Access Compliance Report

Public Rights-of-Way

(Curb Ramps)

Intersection ID: N/A	Main Street: S BREVARD ST	Cross Street: E 3RD ST	Location: W
ADA ID: C031A2D700C4	Ramp Type: Perp	Initial Pass/Fail: Fail	Overall Compliance: No
Severity Score: 22.5			
Codes/Mitigation Info/Possible Solution		Field Measurements/Component Compliance

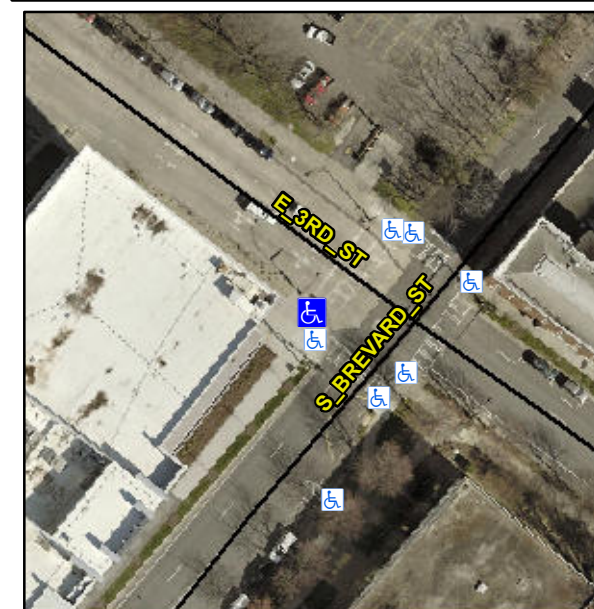
Not Found, R304.5.1, R304.2.2, R304.5.3

Compliance	Description	Data	Compliance	Description	Data
N/A	Ramp Length (in)	71.0	No	Ramp Slope (%)	10.5
No	Ramp Width (in)	45.0	No	Ramp XSlope (%)	2.8
N/A	Flare Type LT	N/A	N/A	Flare Type RT	N/A
N/A	Flare Slope LT (%)	N/A	N/A	Flare Slope RT (%)	N/A
N/A	Flare Traversable LT?	No	N/A	Flare Traversable RT?	No
N/A	Landing Length (in)	N/A	N/A	DWS Provided?	N/A
N/A	Landing Width (in)	N/A	N/A	DWS Contrast?	N/A
N/A	Landing Slope (%)	N/A	N/A	DWS Length (in)	N/A
N/A	Landing X Slope (%)	N/A	N/A	DWS Full Width?	N/A
N/A	Landing Curb? (Y/N)	N/A	N/A	DWS Offset (in)	N/A
N/A	Shared Landing?	N/A			
N/A	Gutter Ponding?	N/A	N/A	Gutter Slope (%)	N/A
N/A	Gutter Lip Ht (in)	N/A	N/A	Gutter X Slope (%)	N/A
N/A	Painted X Walk1?	Yes	N/A	Painted X Walk2?	N/A
	X Walk 1 Direction	To NE		X Walk 2 Direction	N/A
N/A	X Walk 1 Width (in)	102.0	N/A	X Walk 2 Width (in)	N/A
	X Walk 1 Slope (%)	1.2		X Walk 2 Slope (%)	N/A
	X Walk 1 X Slope (%)	0.7		X Walk 2 X Slope (%)	N/A

Remove & Replace Entire Ramp.
